223 ELM STREET
OAKWOOD HISTORIC
DISTRICT (HOD-G)

APPLICATION FOR A CERTIFICATE OF APPROPRIATENESS – STAFF REPORT

085-18-CA 223 ELM STREET

Nature of Project: Implementation of master landscape plan; replacement of front walk; installation of a side yard walk; installation of retaining wall; and installation of a drainage system; remove crape myrtle tree

Examples of grey bricks in Oakwood:

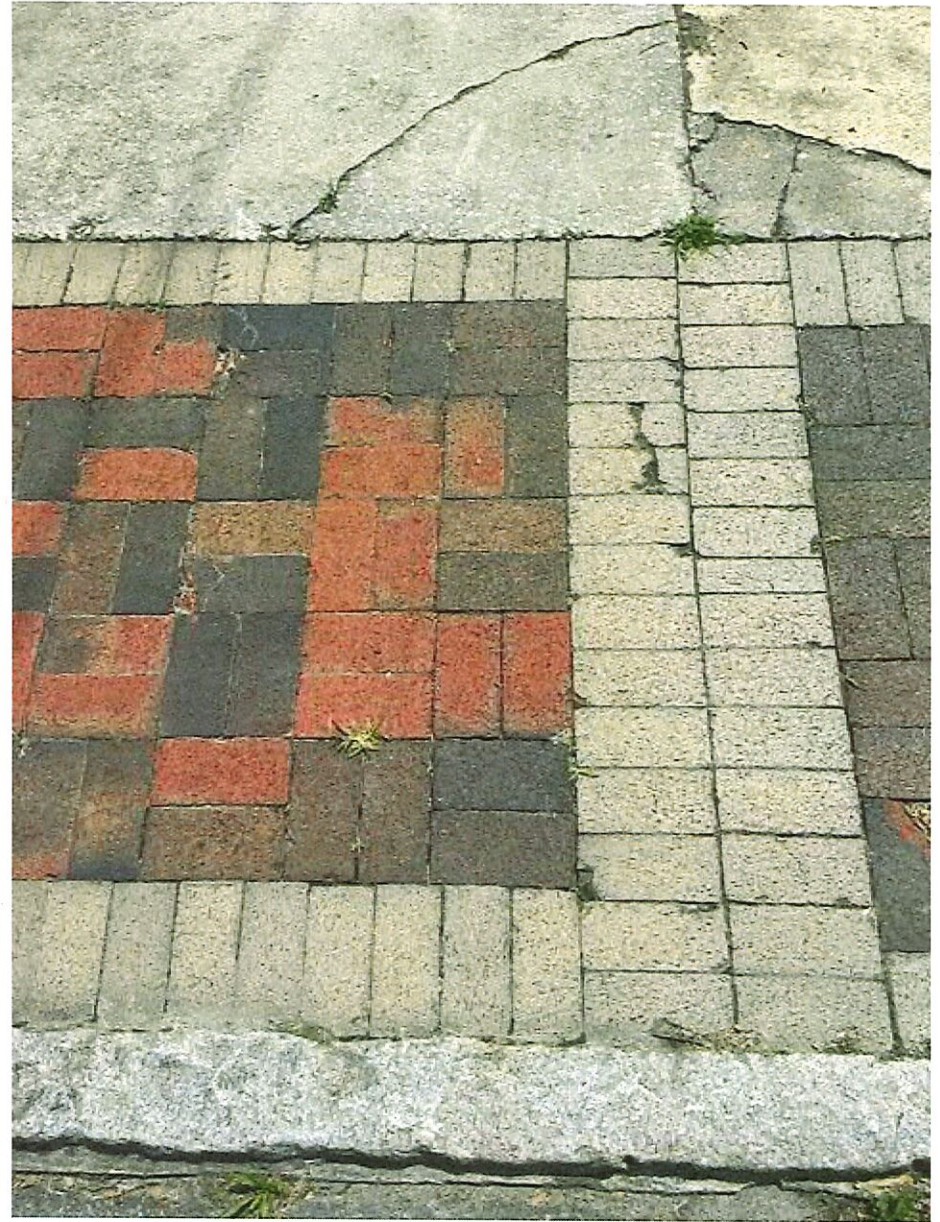
- 2* Red tone brick is predominant in the historic district. However, the applicant did provide two examples of properties in the district that have grey bricks installed: Oakwood Cemetery and 114 N Bloodworth Street. Oakwood Cemetery is not within the Historic Overlay District. The bricks on Bloodworth Street either predate the district or were installed without a COA. Evidence was not provided to show that the use of techo brick meets the guidelines.

223 ELM ST. - general layout + diag.
(revised 6.04.10)

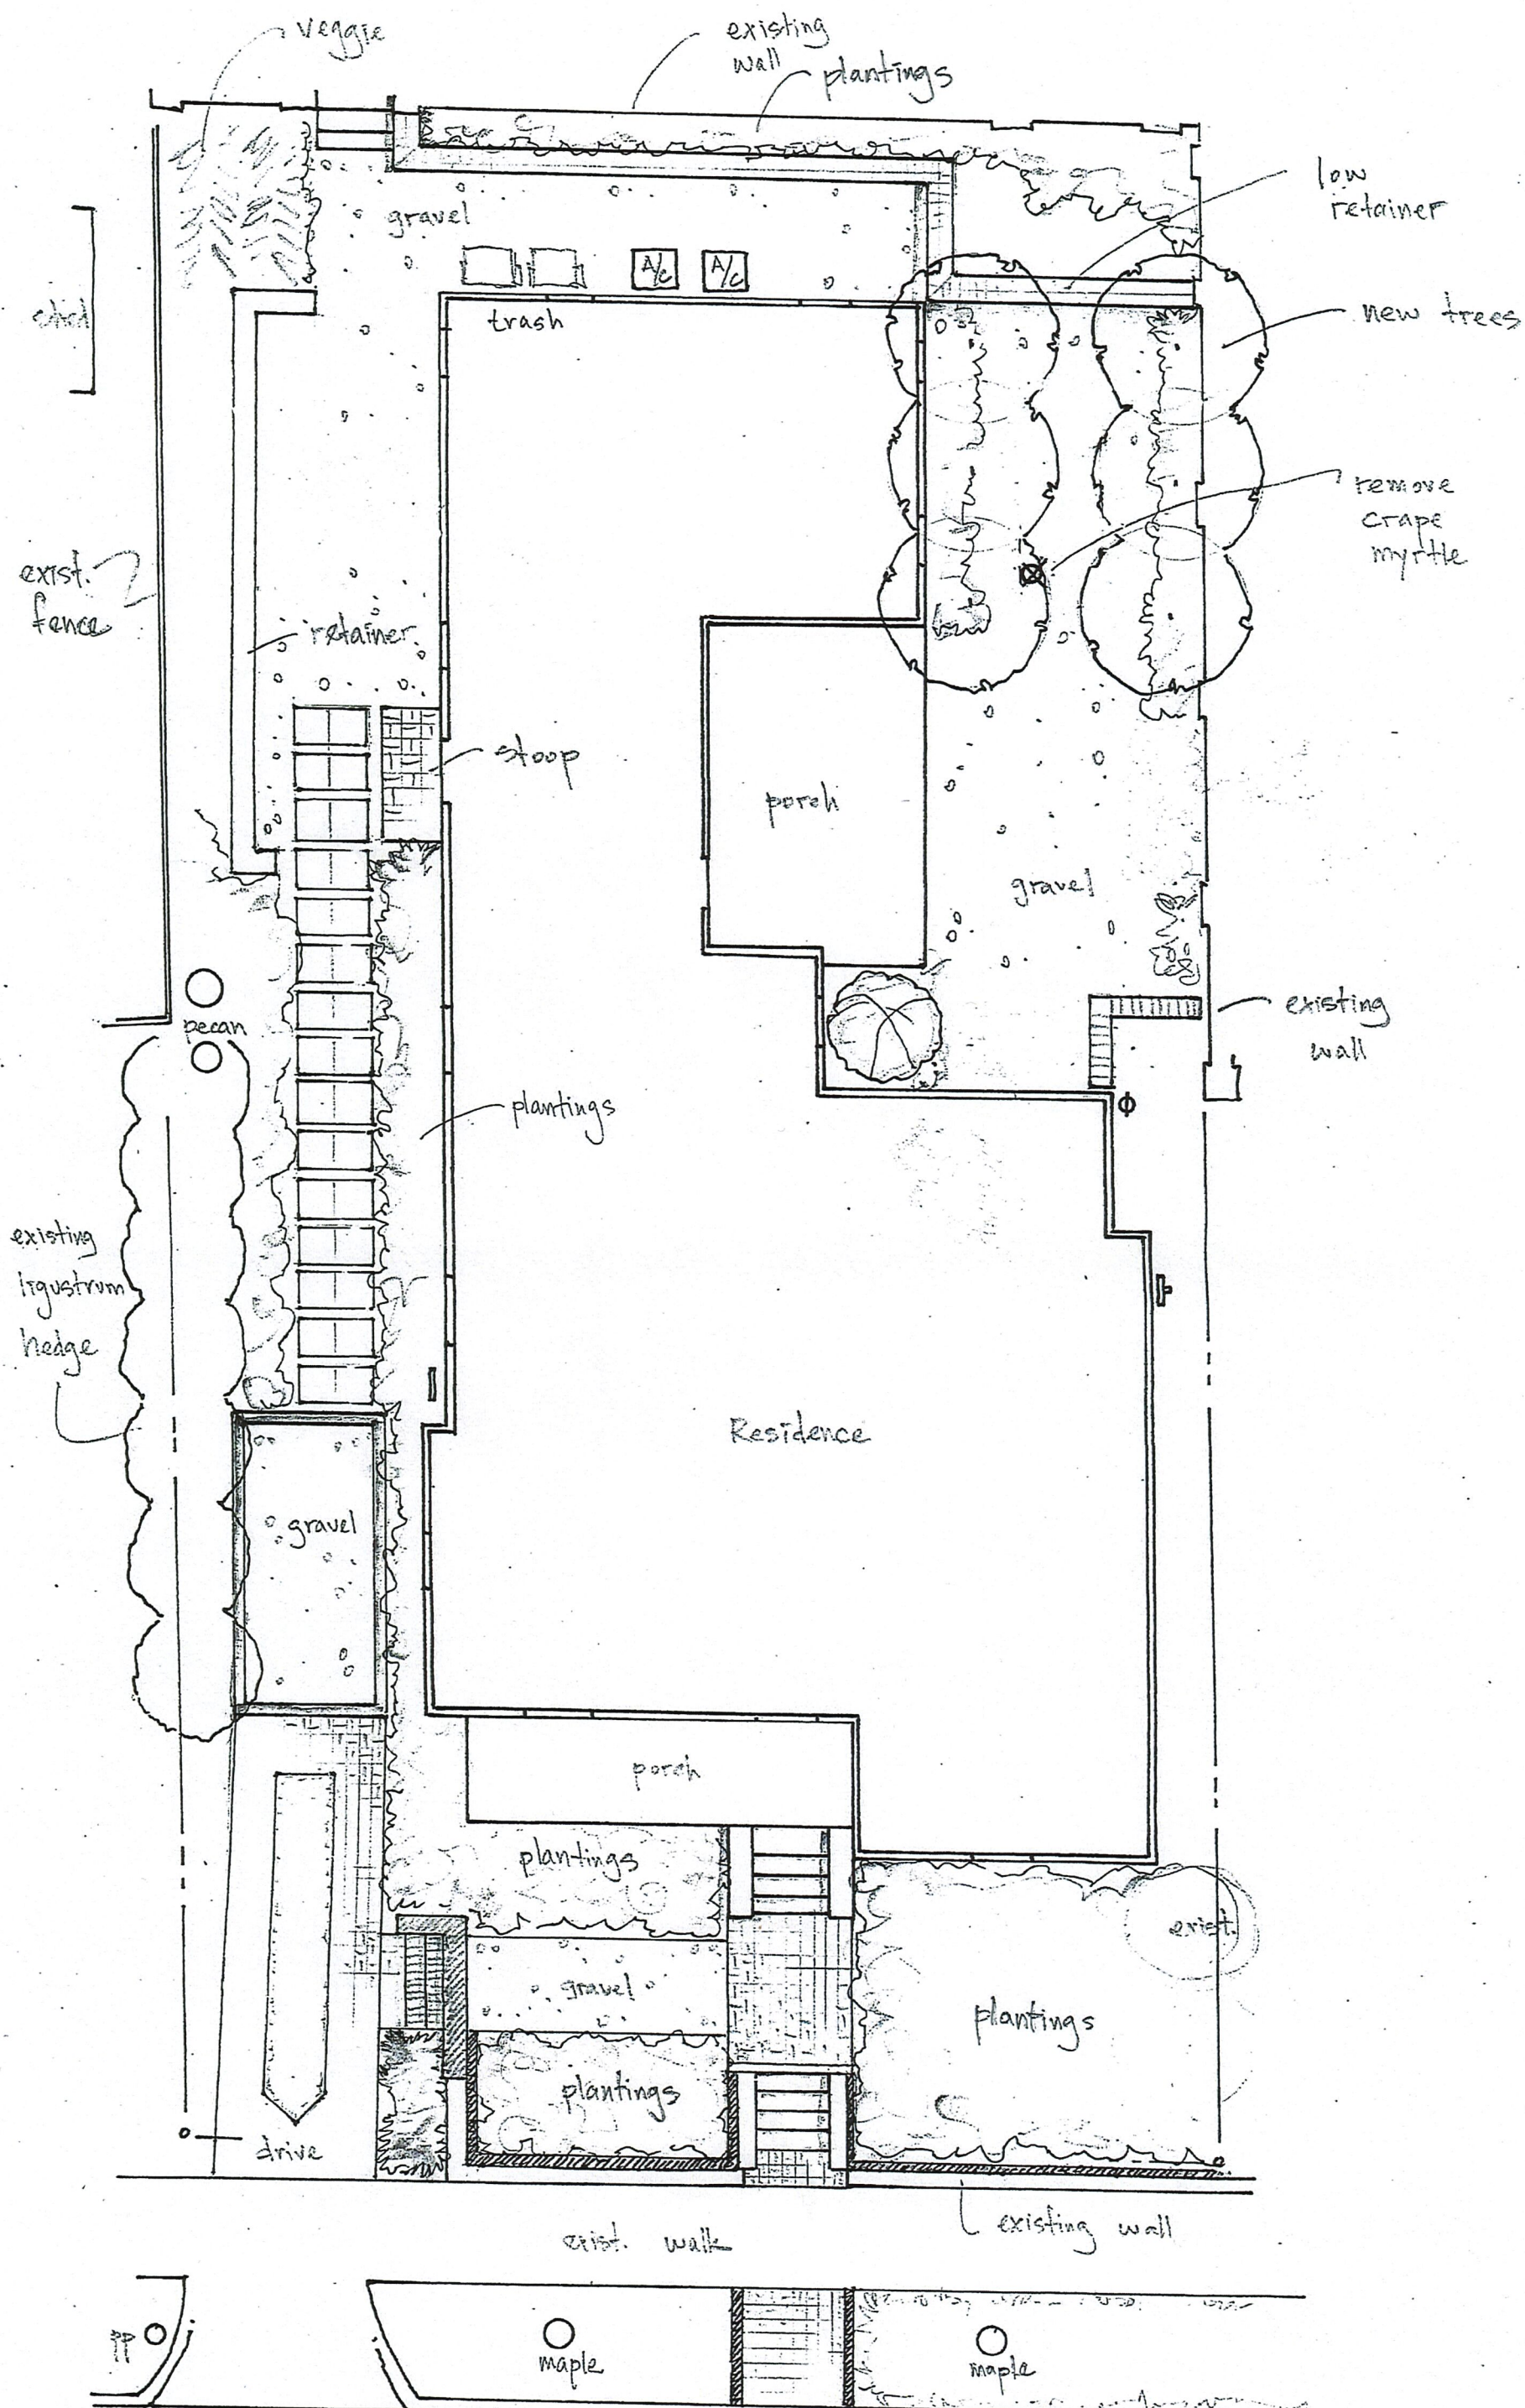
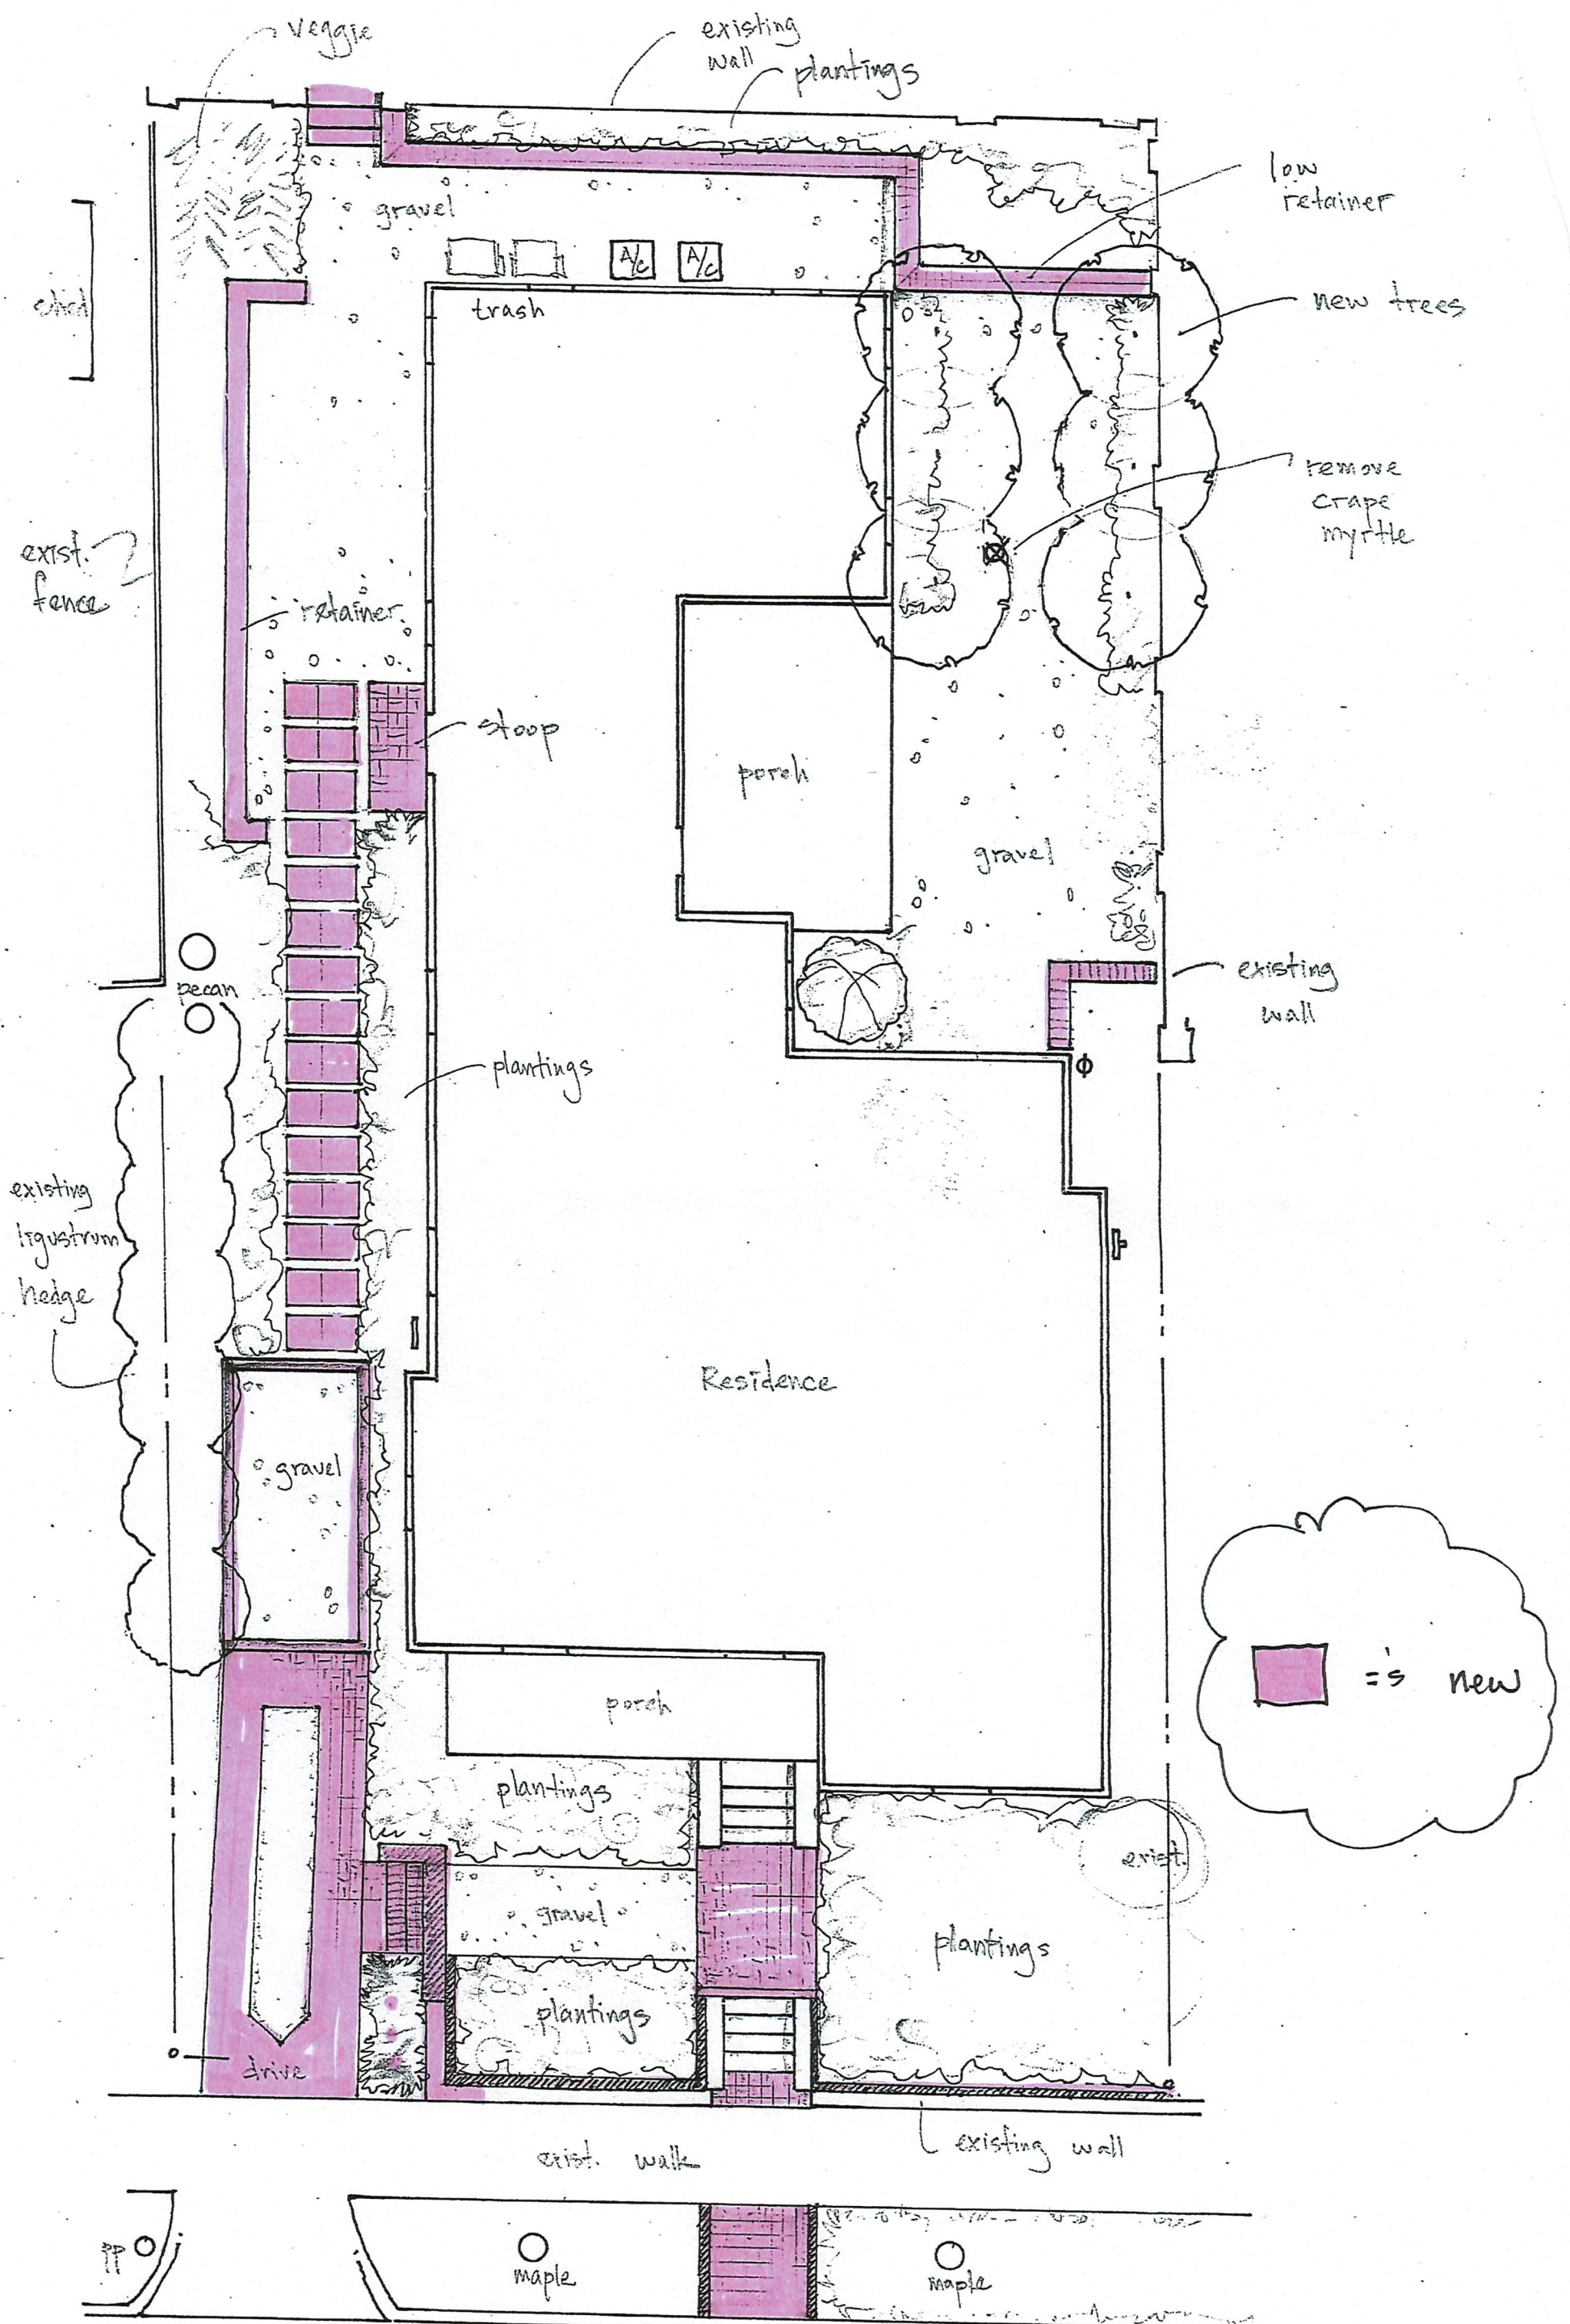
1. Please provide details of the fire pit and storage areas that are noted on the drawing. If you are not ready to proceed with those two items, please remove them from the drawings. **Removed.**

2. Similarly, is the grill area built-in? **No.** If not, please remove this from the drawing. Items such as standard grills, trashcans, and furniture, which are not a part of the landscape, should not be shown on the drawings. Additionally, please remove the dining table shown on the drawings as well. If these items will be placed on a pad of any material, please show the pad noting the material without the furniture/removable items drawn in.

5. The extent of the detail on your proposed plan was excellent, could you also provide a drawing of the existing conditions in similar detail? Additionally, please provide an annotated version of your proposed plan that details what is existing and what will be new. **Attached.**

223 ELM ST.
front gravel path detail

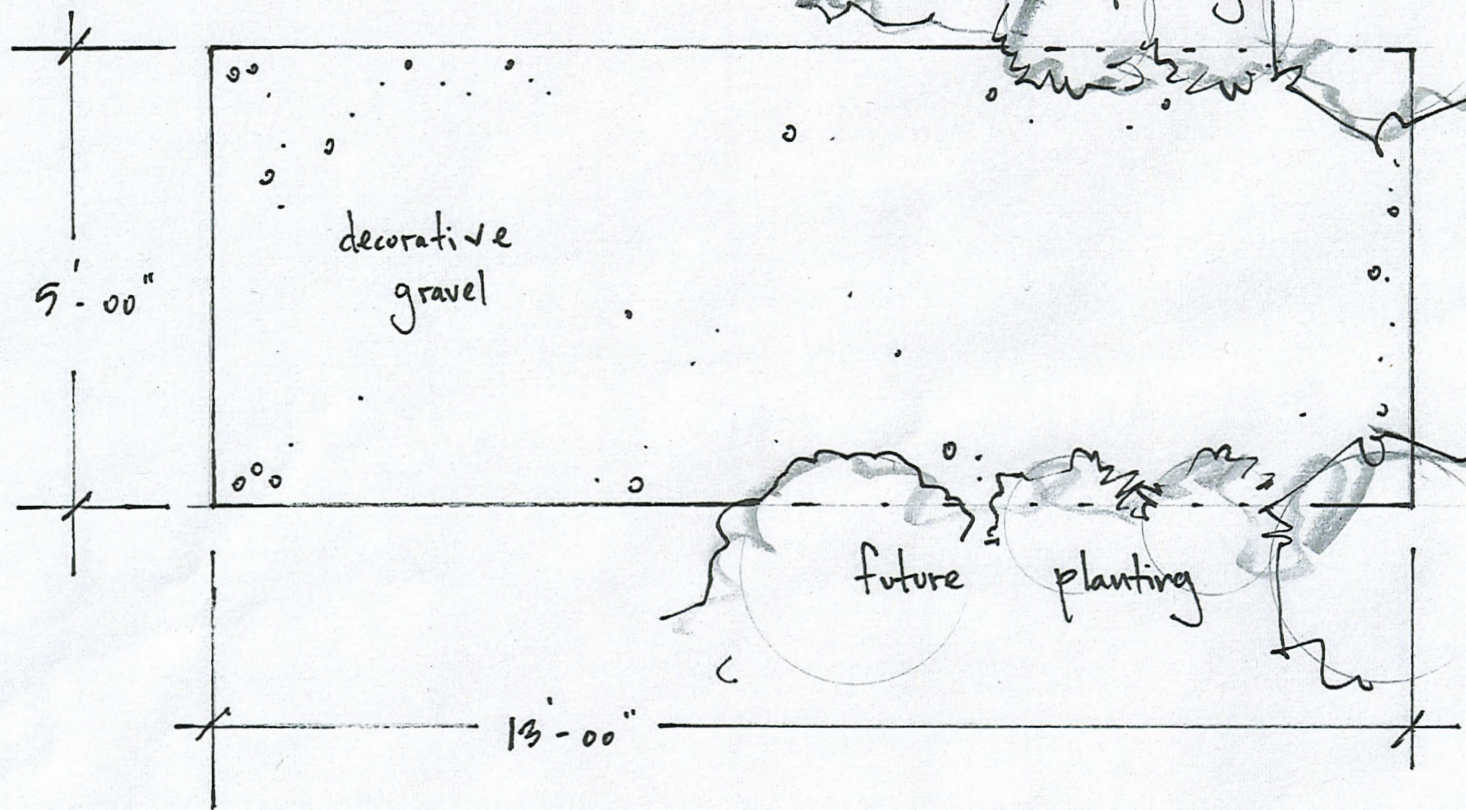
- 6* The gravel front walk (perpendicular to the proposed brick front walk) is shown in the drawings as equaling or exceeding the width of the brick front walk. This is atypical. The gravel walk should be subservient to the brick front walk.

future plantings will be placed close to gravel edge, "spilling" onto path, thus creating a softer line and a more slender path than how it looks on layout plan.
